Pentium[®] Processor Specification Update

Release Date: June, 1997

Order Number 242480-028

2. **Incorrect TCP Pinout Drawing**

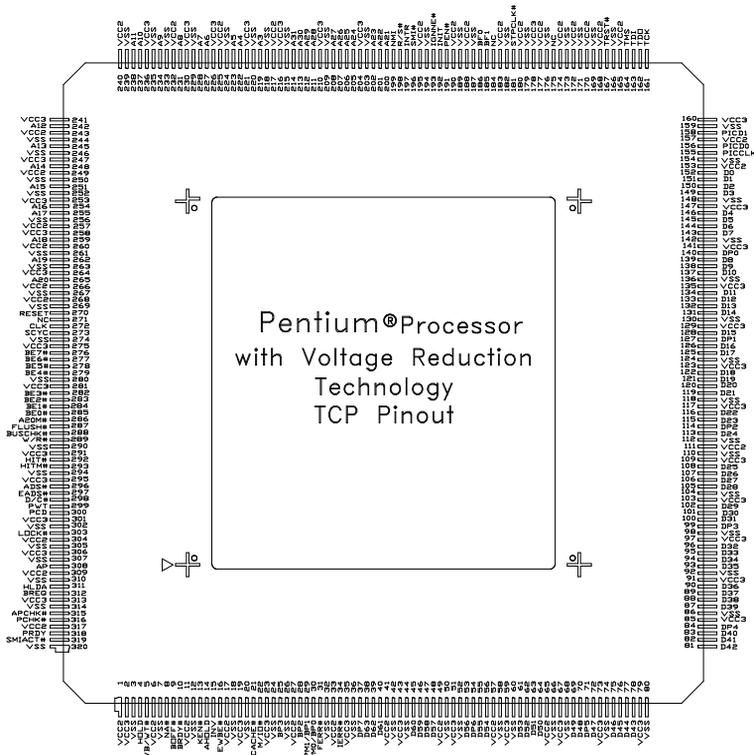
The TCP pinout drawing on page 8 of the *Pentium Processor with Voltage Reduction Technology* datasheet was inadvertently rotated. The correct orientation is shown below.

Figure 14-1. Maximum Undershoot Level, Undershoot Threshold Level, and Undershoot Threshold Duration

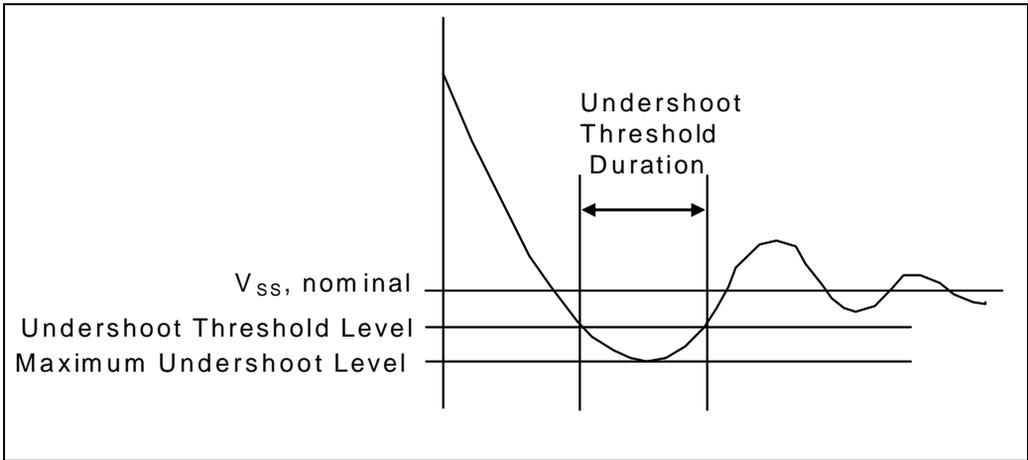
MAXIMUM RINGBACK SPECIFICATION: The maximum ringback of CLK associated with its low state (undershoot) must not exceed 0.8V as shown in Figure 14 -1.

UNDERSHOOT THRESHOLD DURATION SPECIFICATION: A snapshot of the clock signal should be taken at 500 mV/div and 500 pS/div (for CLK). Adjust the vertical position and horizontal offset position to view the threshold duration. The undershoot threshold duration is defined as the sum of all time during which the clock signal is below -0.5V within a single clock period. The undershoot threshold duration must not exceed 20% of the period.

This undershoot specifications are illustrated graphically in Figure 14-1 and Figure 14-2.

Figure 14-2. Maximum Ringback Associated with the Signal Low State

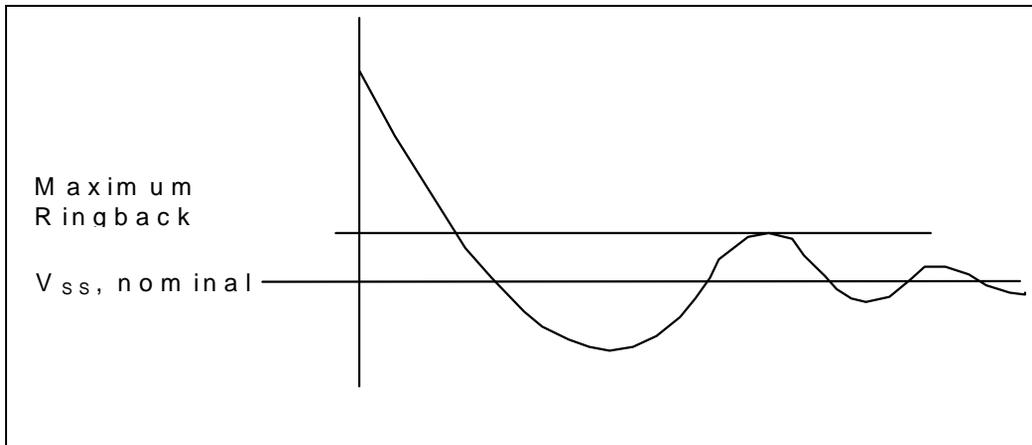
MAXIMUM UNDERSHOOT AND MAXIMUM RINGBACK SPECIFICATIONS: The display should show continuous sampling (e.g., infinite persistence) of the waveform at 500 mV/div and 5 ns/div (for CLK) for a recommended duration of approximately five seconds. Adjust the vertical position to measure the maximum undershoot and associated ringback. There is no allowance for crossing the maximum undershoot or maximum ringback specifications.
